Hardings Subdivision, Lot 55, Administrative Subdivision Plan No. 620210110 with Preliminary/Final Water Quality Plan

ADMINISTRATIVE SUBDIVISION PLAN NO. 620210110: Staff recommends approval of the Administrative Subdivision Plan and the Preliminary/Final Water Quality Plan based on documents submitted in ePlans on May 21, 2020 and subject to the following conditions:

ADMINISTRATIVE SUBDIVISION PLAN
LOT 55 - HARDINGS SUBDIVISION
2605 Sagebrush Terrace, Silver Spring, MD 20905
Tax Map # KR24 - WSSC Base Map # 218NE03
BURTONSVILLE ELECTION DISTRICT #5, MONTGOMERY COUNTY, MARYLAND
Formerly know as HARDINGS SUBDIVISION - OUTLOTS A, B, & D

Figure 4 – Administrative Subdivision Plan

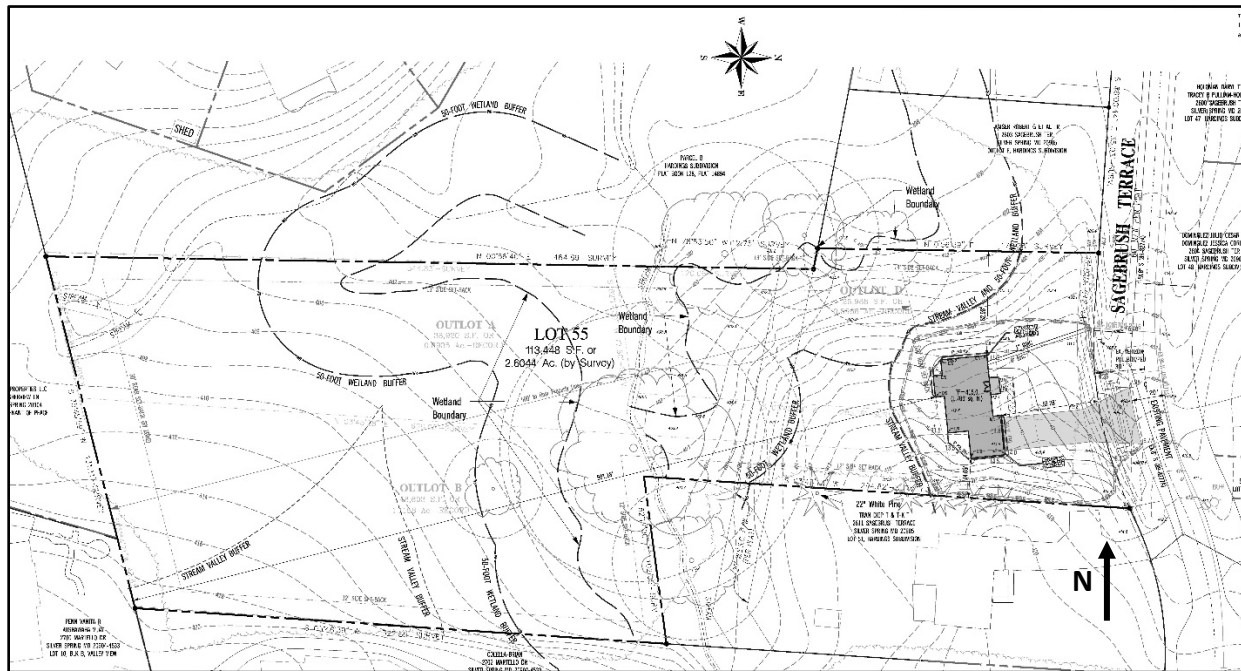
4. The site plan should require maximum preservation of existing trees, on the property, particularly a large pin oak tree and a medium size pin oak or maple tree directly to the west of Outlot D along the property line with Outlot C, and the larger of the several cherry trees at the northwest corner of Outlot D.

5. The site plan should prohibit any development of or impinging upon Outlot A and Outlot B.
6. The site plan does not show the proposed location of a driveway or parking surfaces. These should be shown as they affect surface water runoff, per #7 below.

- a. Runoff to the west of the proposed structure needs addressed to alleviate any addition to water flows that would add to existing surface water flows noted above. Runoff to the south would enter the wetland / stream area and be of lesser concern.

- b. Protect the trees
 - c. While we see two french drains on the site plan, one to the southwest and one to the north of the proposed structure, these would appear insufficient to address this runoff issue, and do not address paved surfaces. Final plans should numerically demonstrate their adequacy to address the points in the letter.

- d. The proposed site plan shows an eight (8) to ten (10) foot downward slope to be constructed on the west side of the proposed structure.
 - i. There should be a means to capture any surface water flow at the base of this area and direct it to an additional drywell or enlarge the proposed drywell at the southwest corner of the proposed structure, or create a water garden to retain runoff on-site, all with appropriate contours.

- ii. The final plan should show the location and size of the proposed driveway and any parking area. The driveway should be located on the eastern portion of the property.

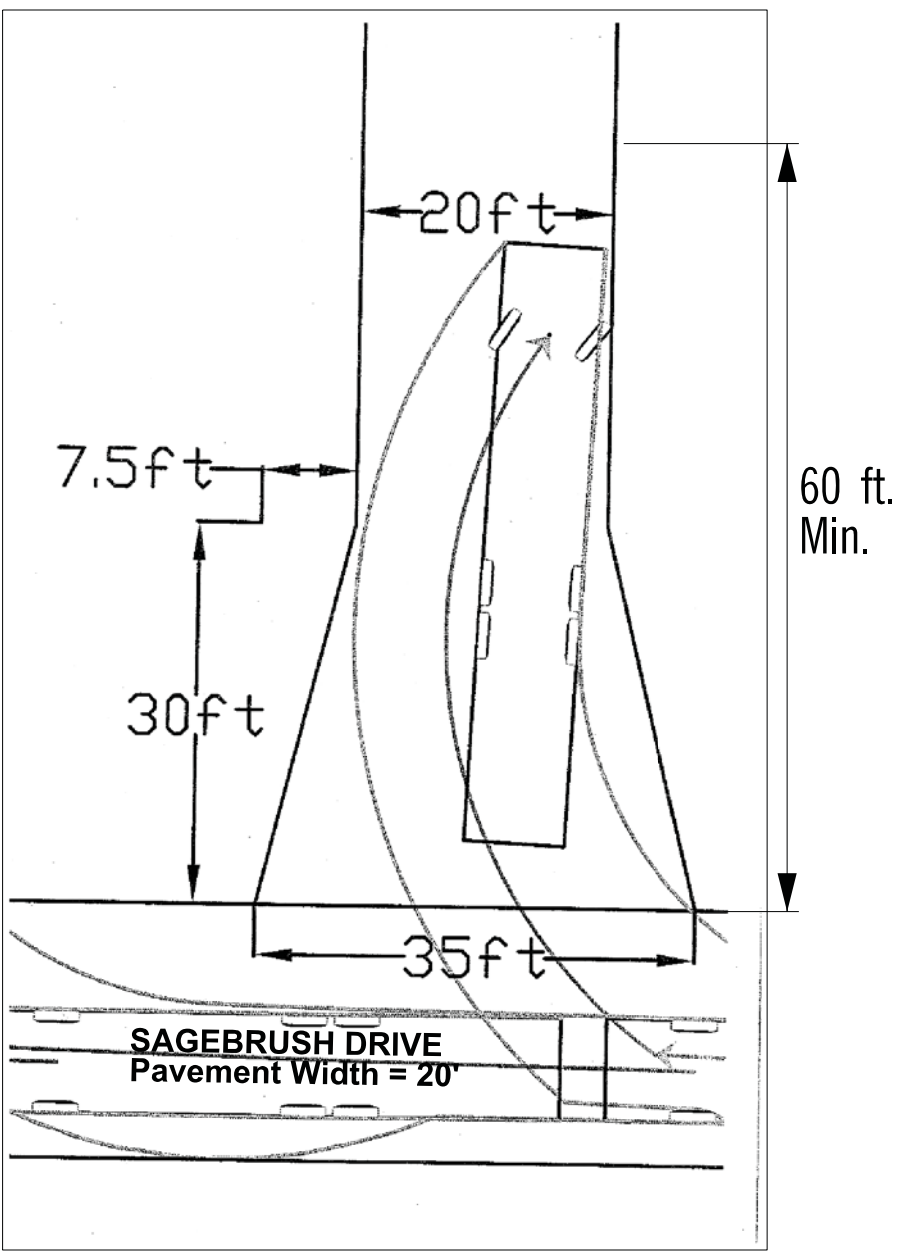
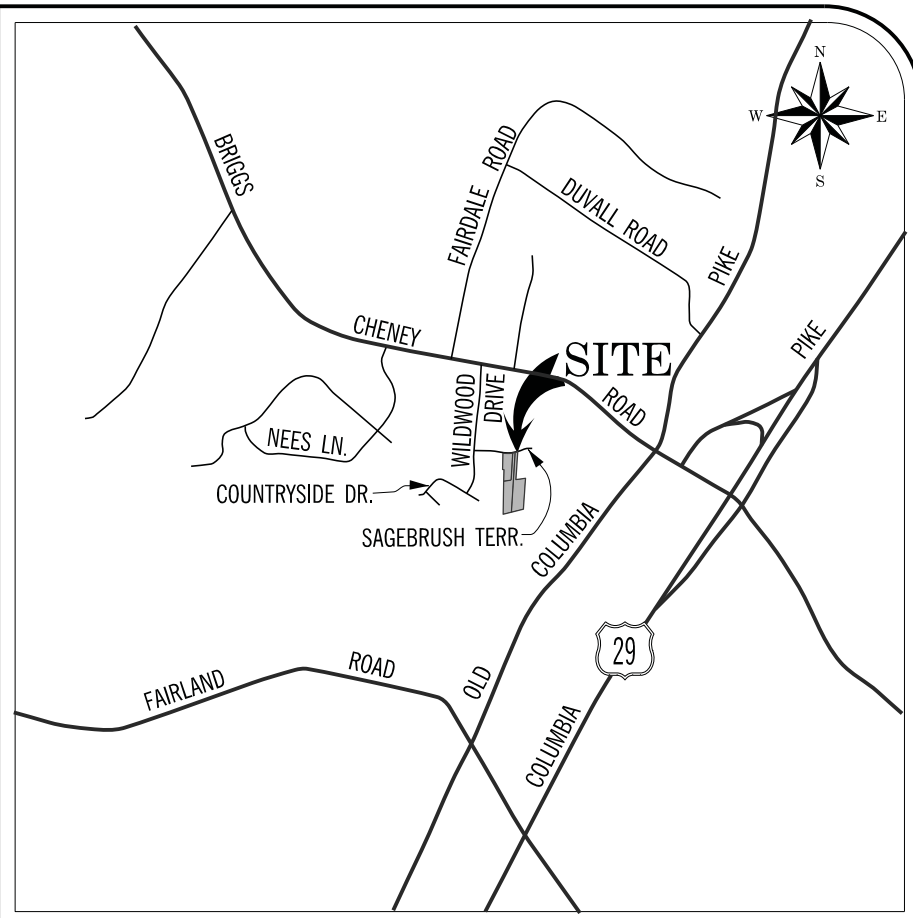
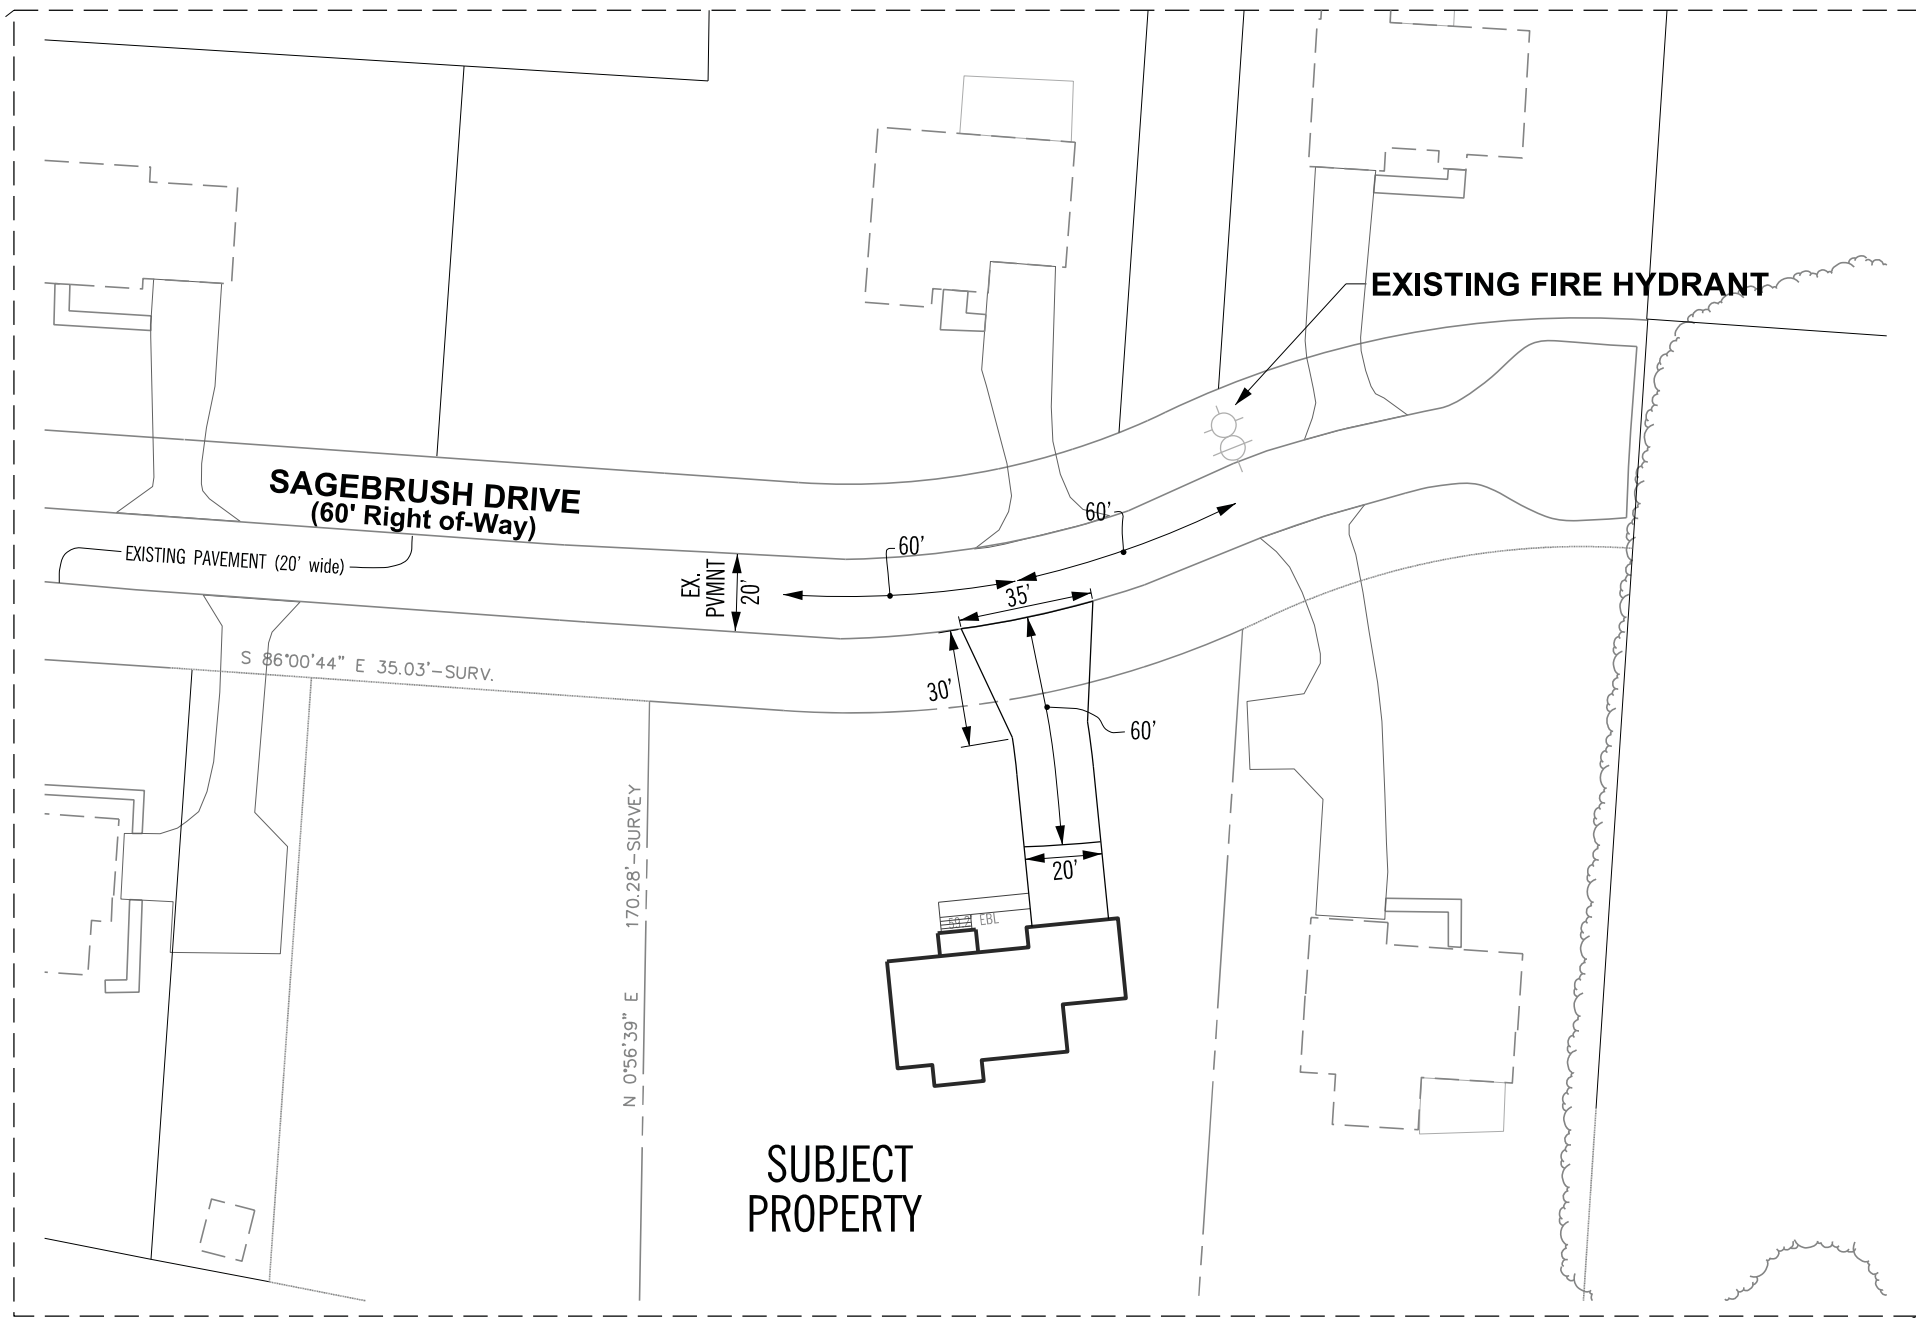
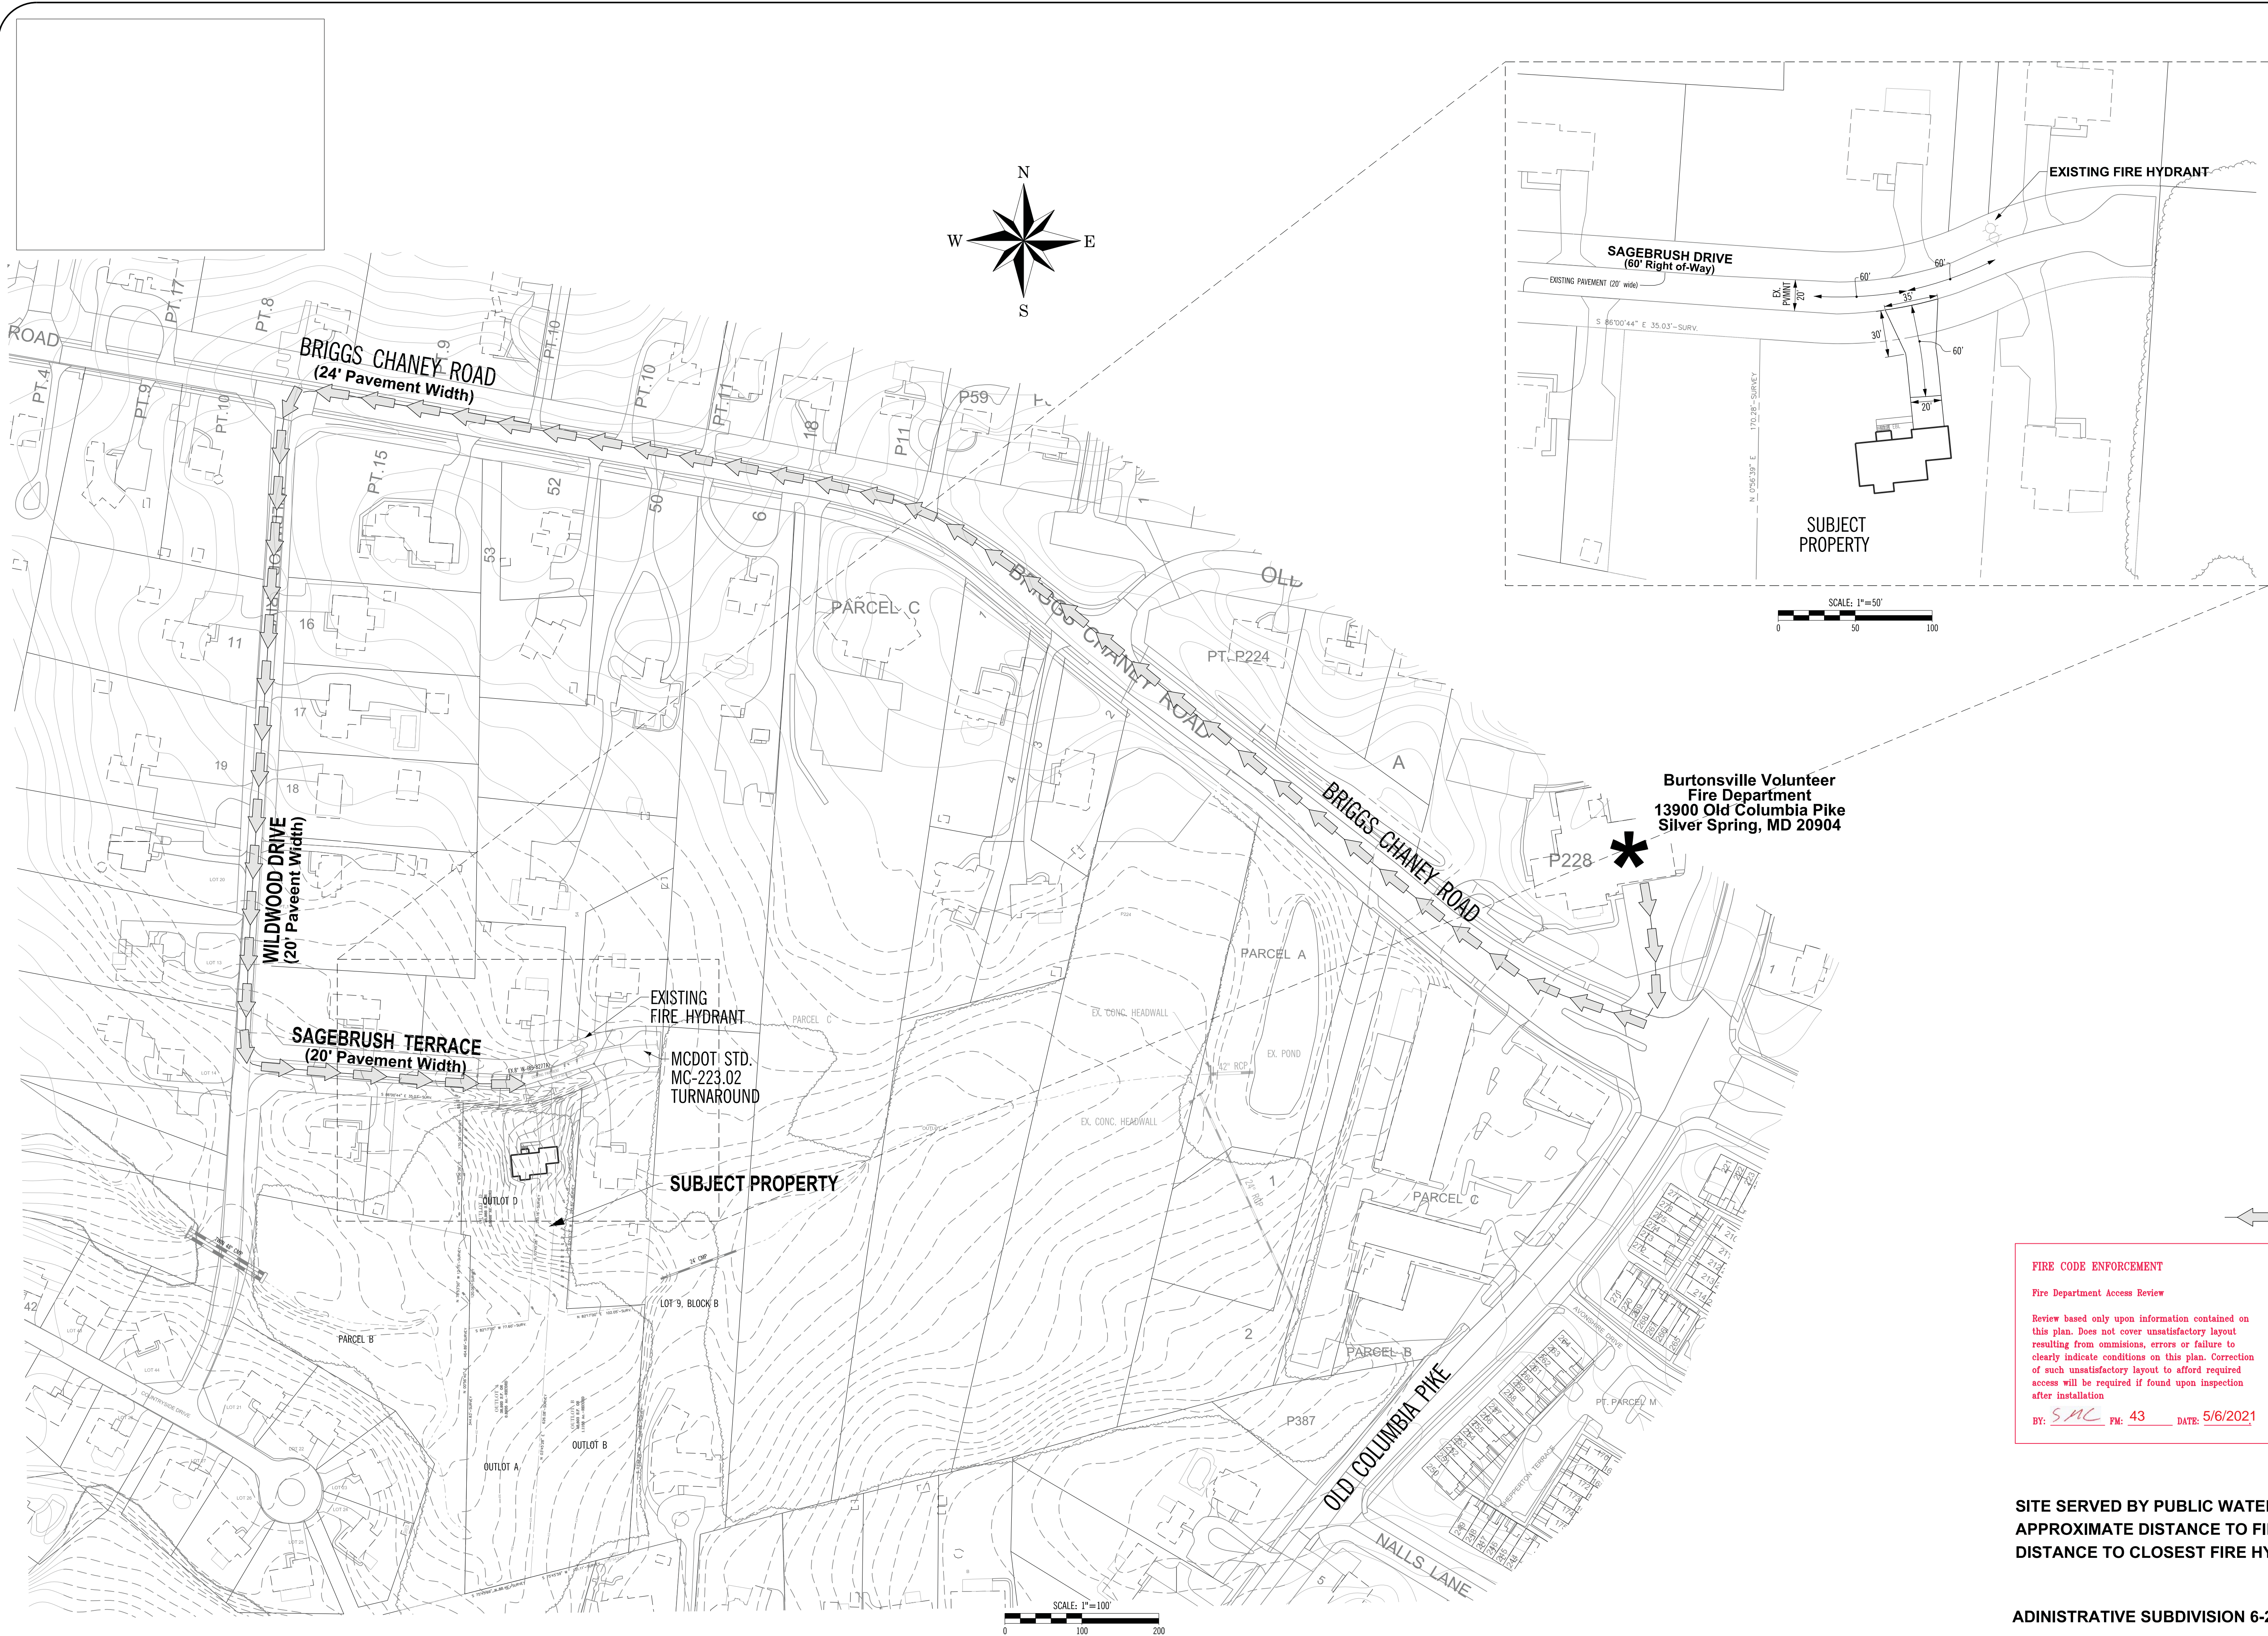
The following items will need to be addressed during the detailed sediment control/stormwater management plan stage:

1. A detailed review of the stormwater management computations will occur at the time of detailed plan review.
2. An engineered sediment control plan must be submitted for this development.
3. Direct as much of the proposed driveway as possible to the proposed micro bioretention structure.
